V2500-A5/D5 PROPULSION SYSTEMS SERVICE BULLETIN

This document transmits Revision 4 to Service Bulletin EV2500-72-0421 and Revision 1 to the Supplement

V2500-ENG-72-0421

ENGINE – HP COMPRESSOR FRONT STUBSHAFT – INTRODUCTION OF A REVISED HP COMPRESSOR
FRONT STUBSHAFT WITH HIGH ENERGY PLASMA COATING

General section through HP Compressor Front Stubshaft
Figure 1

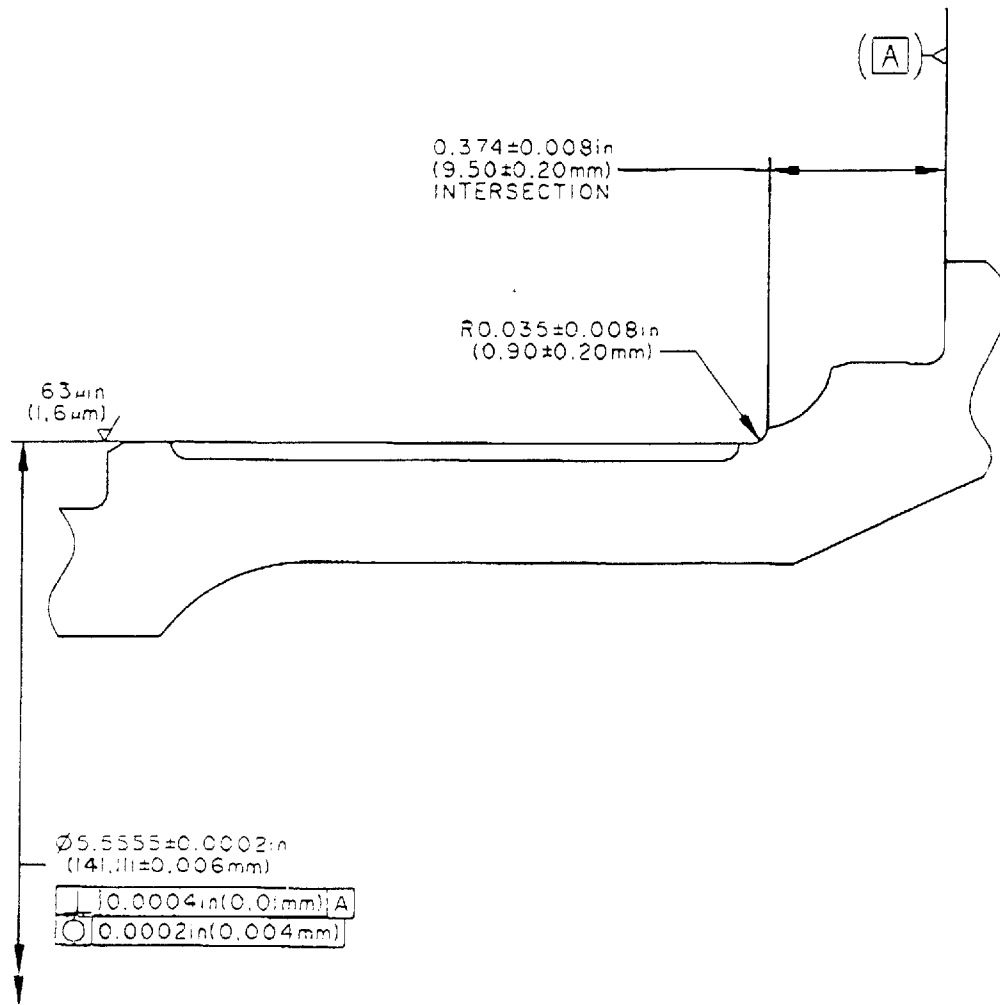
| (5) Remove the hard coating | Refer to Figure 1

Refer to approved vendor process. |

| (13) Grind the hard coating on the HP Compressor Front Stubshaft | Refer to Figures 1 and 2.
| (14) Visually and dimensionally inspect | Refer to Figures 1, 2 and 3.

Rework of HP Compressor Front Stubshaft
Figure 2

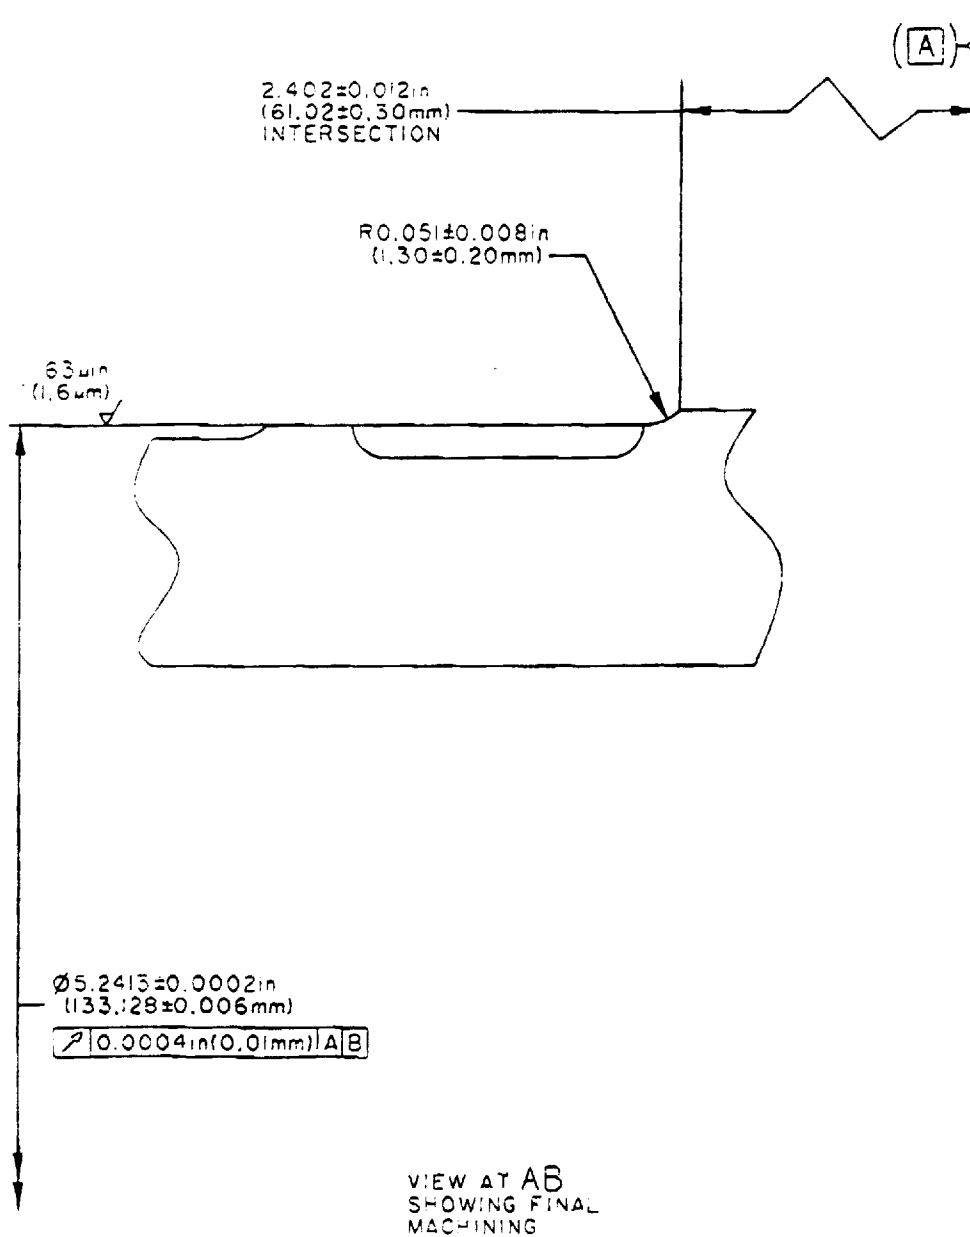
VIEW AT AA
SHOWING FINAL
MACHINING
